NEDO-33173-A, Revision 4

Applicability of GE Methods to Expanded Operating Domains

SUBJECT: FINAL SAFETY EVALUATION FOR GE HITACHI NUCLEAR ENERGY AMERICAS TOPICAL REPORT NEDC-33173P, REVISION 2 AND SUPPLEMENT 2, PARTS 1-3, "ANALYSIS OF GAMMA SCAN DATA AND REMOVAL OF SAFETY LIMIT CRITICAL POWER RATIO (SLMCPR) MARGIN" (TAC NO. ME1891)

Figure 4-1 Void coefficient vs. instantaneous Void Fraction for a Range of Historical Void Fractions at an Exposure of 30 GWd/MT

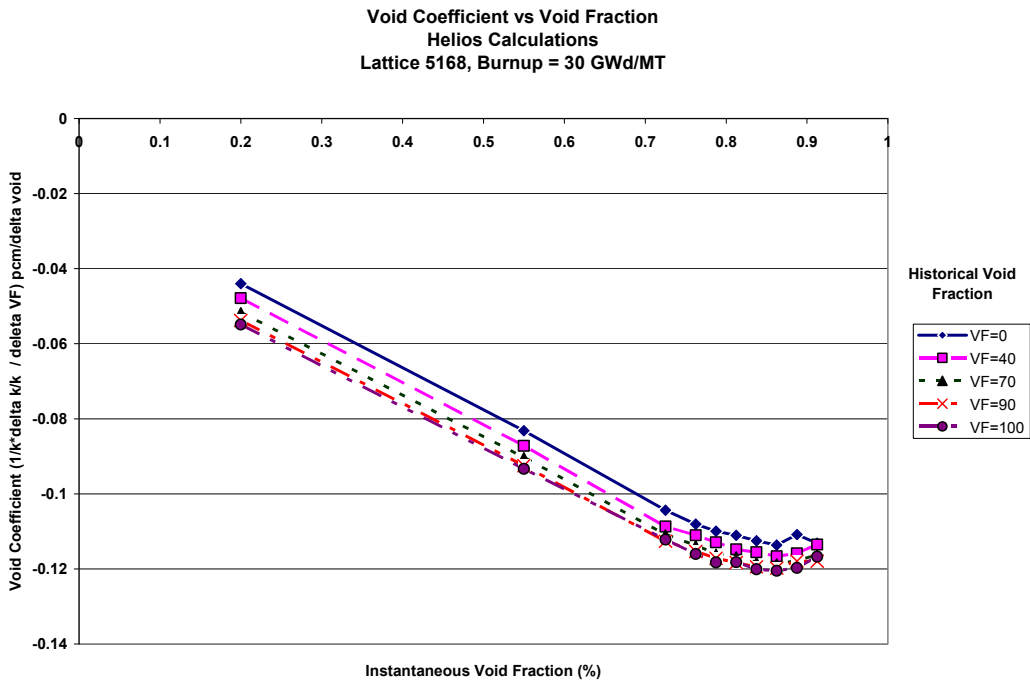
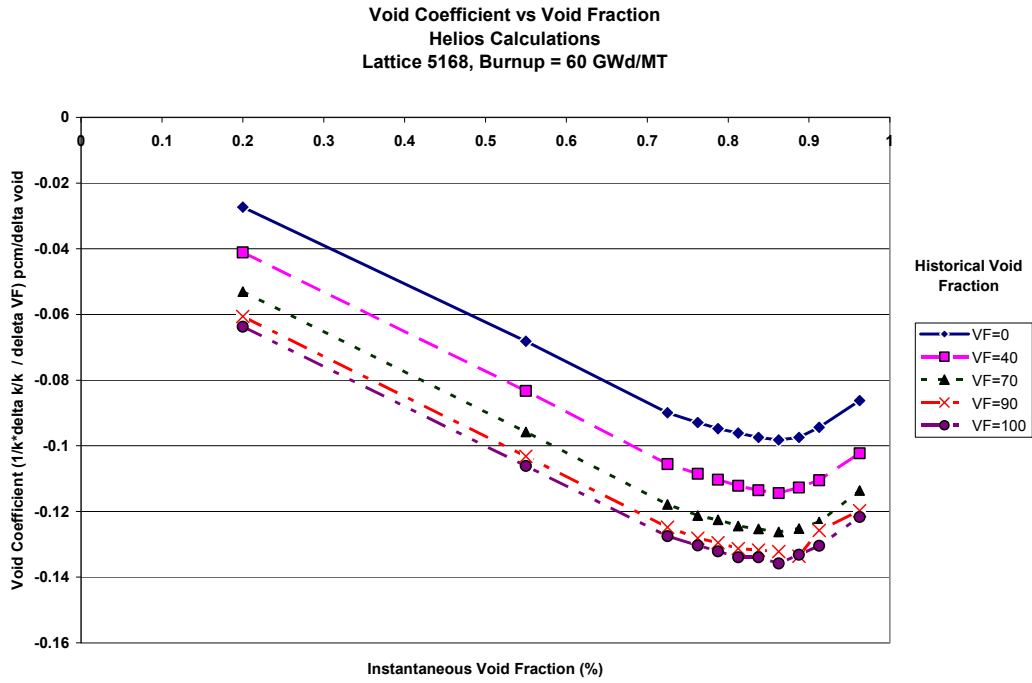
Comparisons of the void reactivity coefficients for the different void history cases and exposures based on ORNL HELIOS calculations are presented in Figure 4-1 and Figure 4-2. Note that additional instantaneous branch points were calculated at the higher void conditions to resolve the non-linearity of the void coefficient with respect to IV fraction at high fuel exposures. The impacts of the different void histories are evident at the higher void fractions with the increasing differences in the void reactivity profiles with increasing exposure. The difference in the profiles [] represents a potential error resulting from GE's methodology. The errors for exposures of about 30 GWd/ST and less are consistent with the [] assumed in the ODYN analysis. However, for higher exposures at high void fractions the error increases []. In addition, the deviation of the void reactivity from a linear variation represents an error that results from the quadratic extrapolation used in GE's methodology. As shown in these figures, at high void fractions and high exposures the profile deviates from linear.

Figure 5-1 Impact of Bypass Voiding on Peak Pin Fission Rate

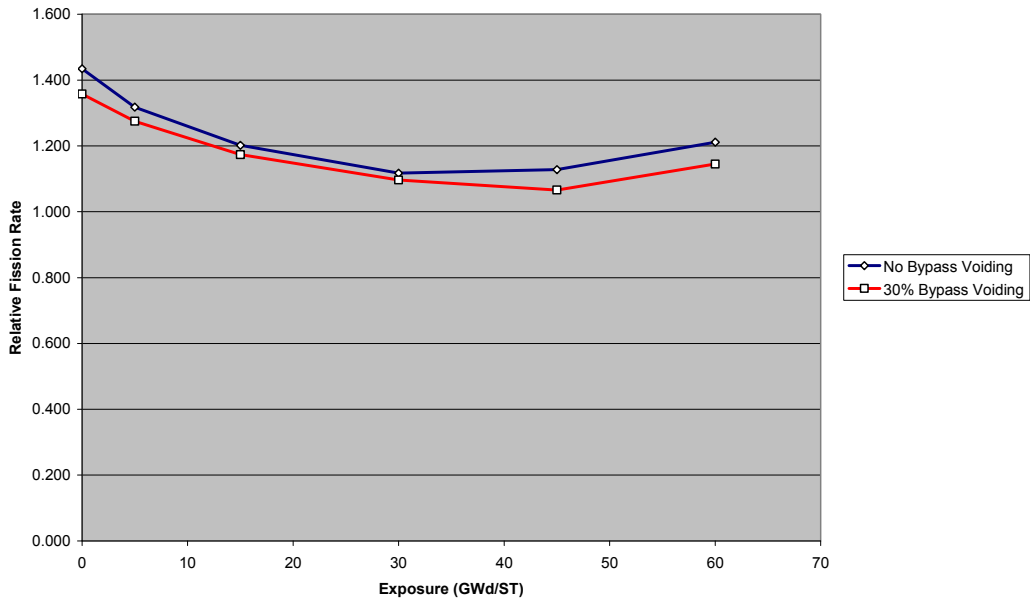
Figure 5-1 provides a comparison of the peak relative pin-fission rate for 90 percent in-channel void fraction with and without a 30 percent bypass void fraction. Figure 5-2 provides a similar comparison, but based on an RMS of the difference of the relative pin-fission rates from unity. This later parameter provides an indication of the overall "flatness" of the lattice pin power distribution. The results indicate, as discussed above, that the peak pin-fission rate is reduced and the lattice pin-fission rate distribution is more uniform (flatter) for the case with bypass voiding. Therefore, as far as lattice peaking is concerned, bypass voiding does not have a negative impact. In addition, the 30 percent bypass voiding considered greatly exceeds the maximum value of 5 percent indicated by GE for steady-state operation.

Figure 7-6 Void Fraction-Quality Relation with Partial Length Rods at Low Flow

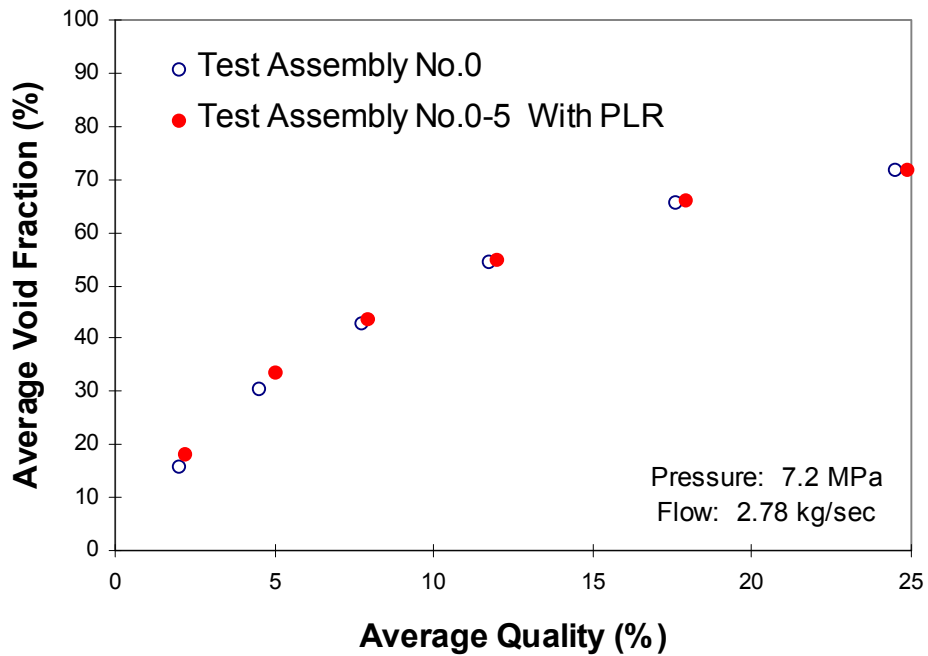
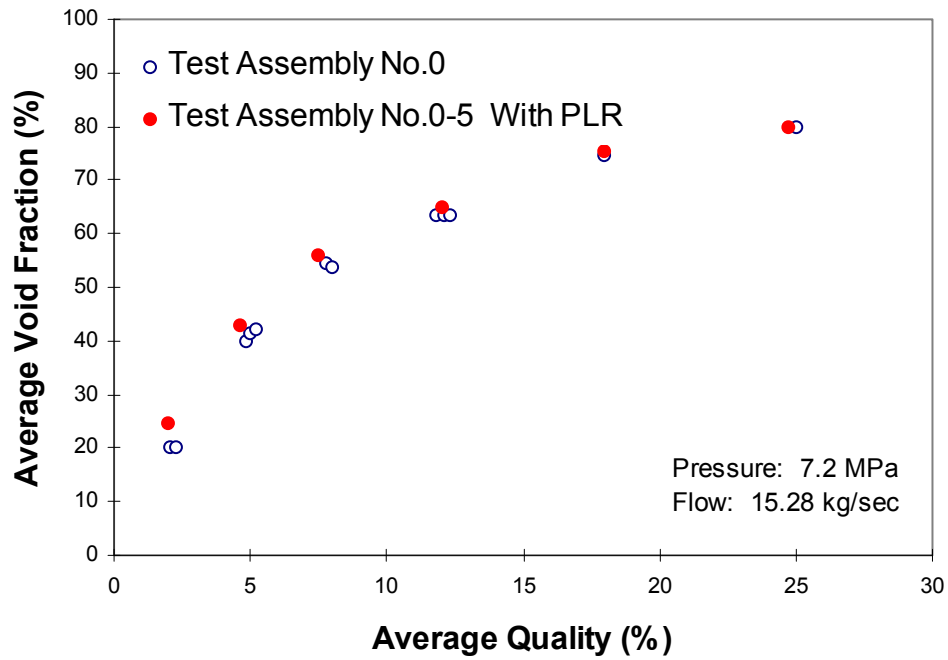
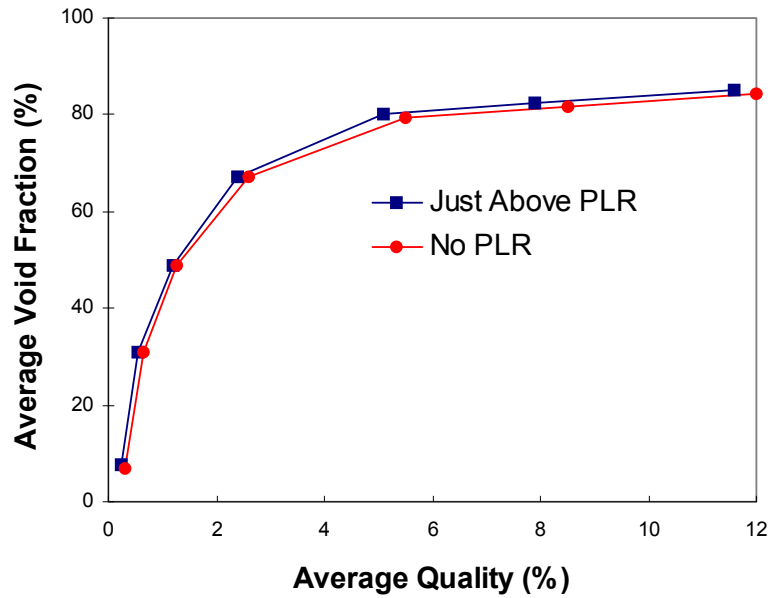
GE presented three plots showing the effect of partial length rods on void fraction (Response to RAI 5.2, Reference 9), which are shown as Figure 7-6 through Figure 7-8. The data in these plots were Japanese data taken from the open literature. The data indicates only a minor change in void fraction between bundles with and without partial length rods. GE noted that the void fraction correlation was not compared to this data because sufficient information about the test apparatus was not available. This limits the usefulness of data since there is no quantitative comparison with Findlay-Dix void that would allow the performance of the Findlay-Dix void-quality correlation to be evaluated for partial length rods.

Figure 2.2-1 Sensitivity of Cold Critical Eigenvalue to EPU Operation

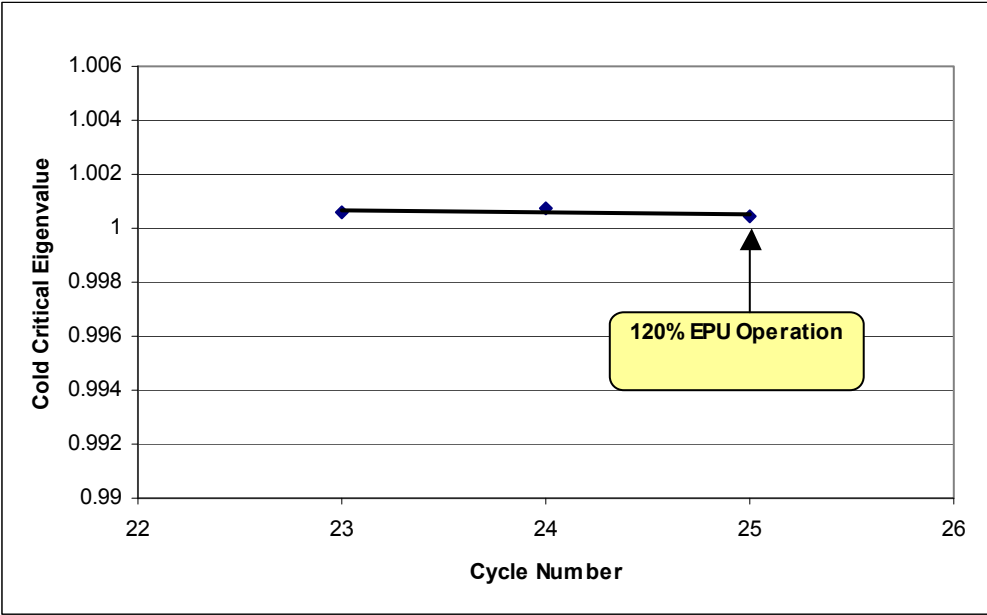
As a final demonstration of these concepts, the trending of the cold eigenvalues for a BWR/4 through a 120% EPU transition is provided in Figure 2.2-1. The scale of the data is consistent with that given in Figure 2-4 of NEDC-33173P. There is no identifiable aberration with the trend because of EPU.

Figure 5-1 – TIP Locations for FitzPatrick

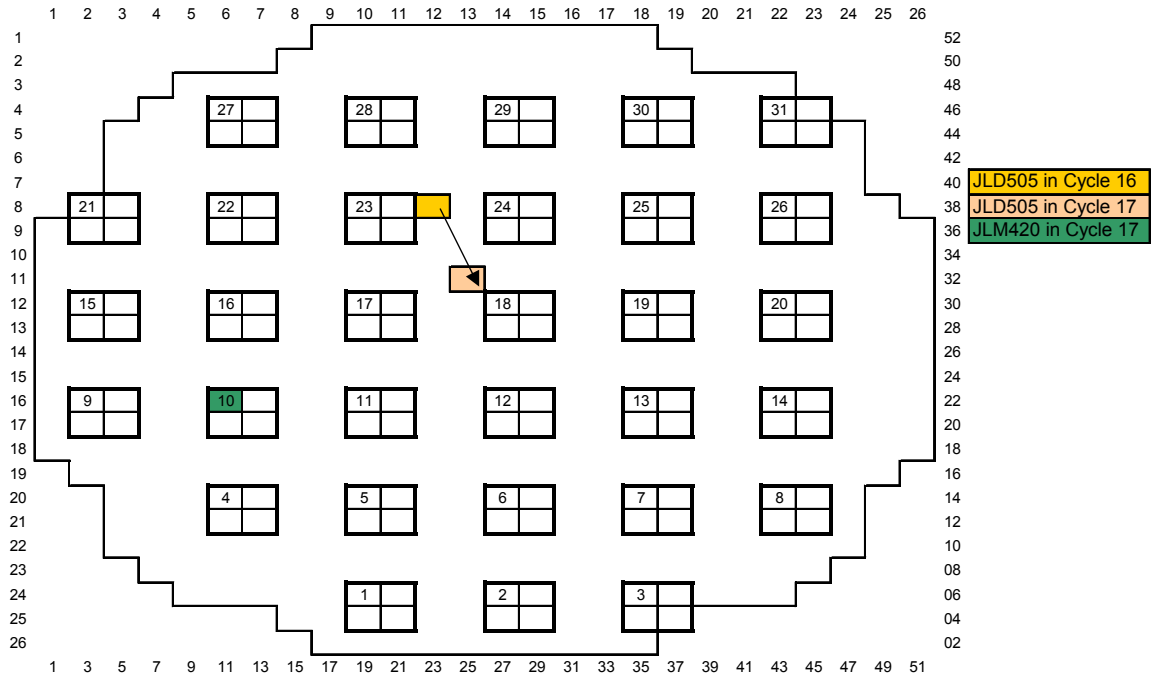
Figure 5-1 provides the locations of the TIP strings in FitzPatrick, with each TIP instrument tube identified by the TIP string number. The TIP string is located at the bottom, right hand corner of the bundle with the TIP string number. Note that the four bundle cells highlighted are the four bundle cells surrounding the TIP string, and do not identify the four bundles around a control rod. Note that JLD505 is not adjacent to an instrument tube in either Cycle 16 or 17, while JLM420 is adjacent to an instrument tube in Cycle 17.
